# WILLIAMSON COUNTY, TEXAS CHANGE ORDER NUMBER: 1

1. CONTRACTOR: The Levy Company		Project:	23IFB21
2. Change Order Work Limits: Sta. 490+00 to	Sta. <b>520+00</b>	Roadway:	RR at Elizabeth Parkway Temp Signals

### Ronald Reagan at Elizabeth Park Temporary Signals Williamson County Project No. 23IFB21

#### Change Order No. 1

SUMMARY OF QUANTITIES

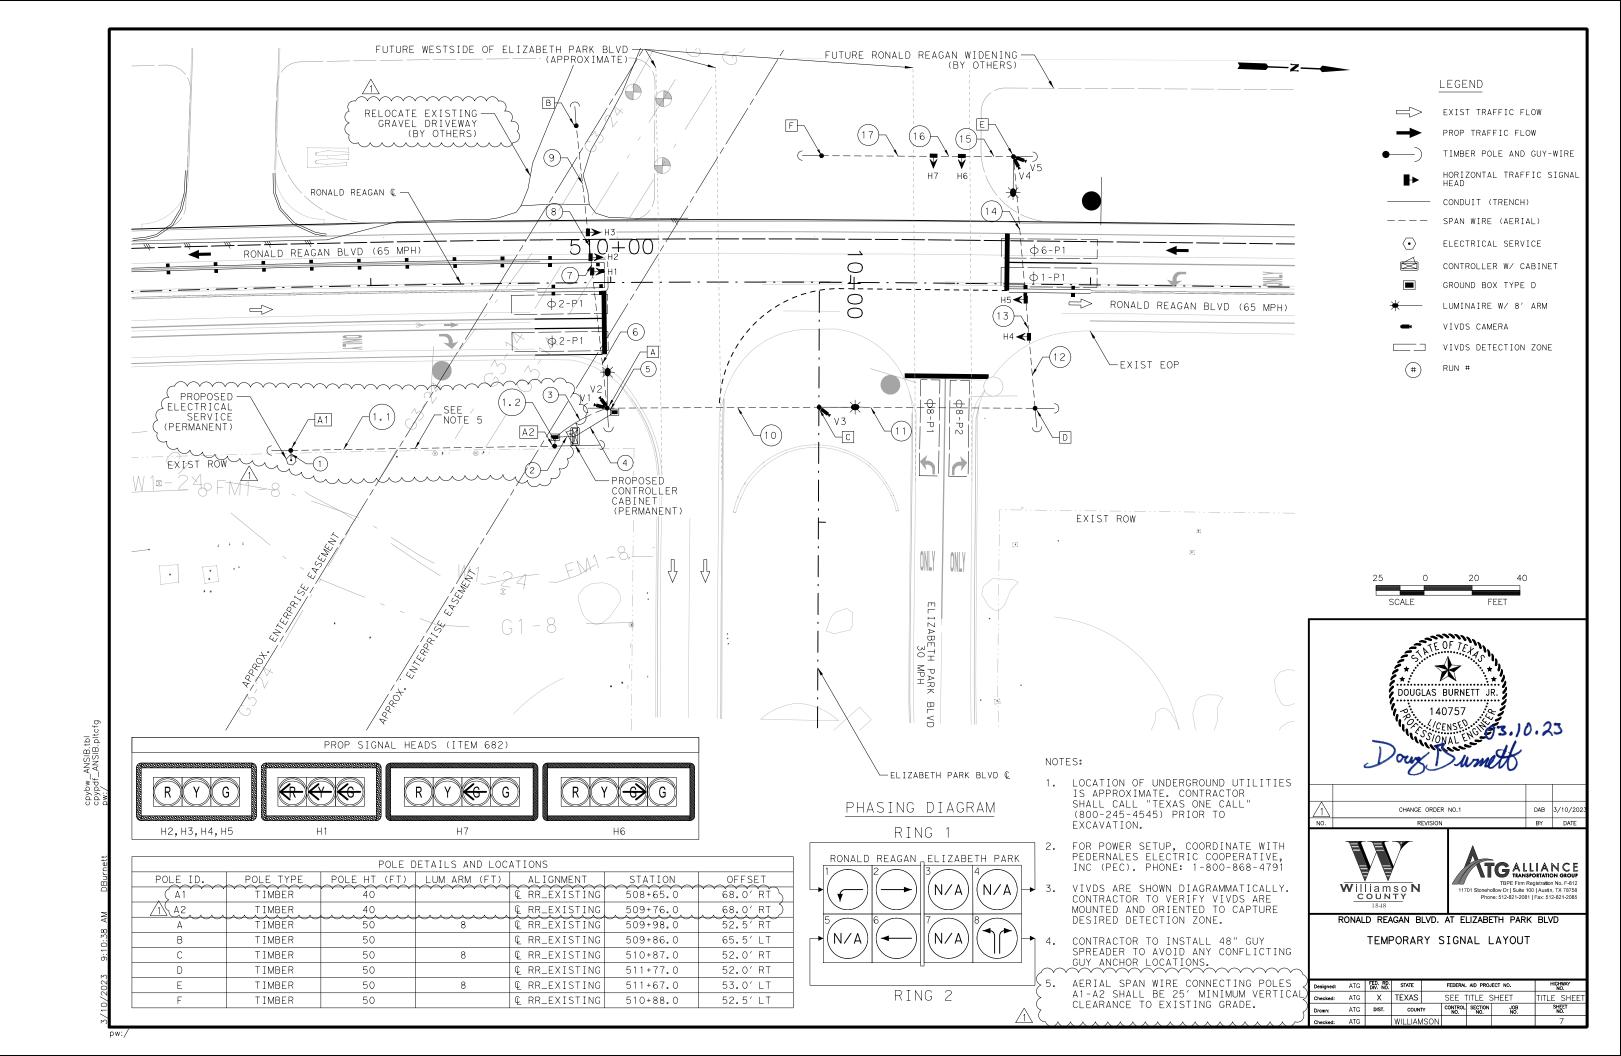
This Change Order will compensate the contractor for quantity adjustments needed due to changes in the field condition. The plans have been revised to span the electric service over the Enterprise gas line versus going underground with the lines.

We offer the attached field change price proposal to account for the changes made to plan shts 2, 7 & 8 in order to address the issues with routing power to the signal intersection. The attached summary table details the quantity changes to the original contract bid items because of the plan revisons, and incorporates corrections made by the Levy team to plan sht 8 (see attached). Furthermore, we have added pricing for five new bid items. An explanation of each new bid item is included below:

$\triangle$	CHANGE ORDER NO.1	DAB	3/10/2023
NO.	REVISION	BY	DATE
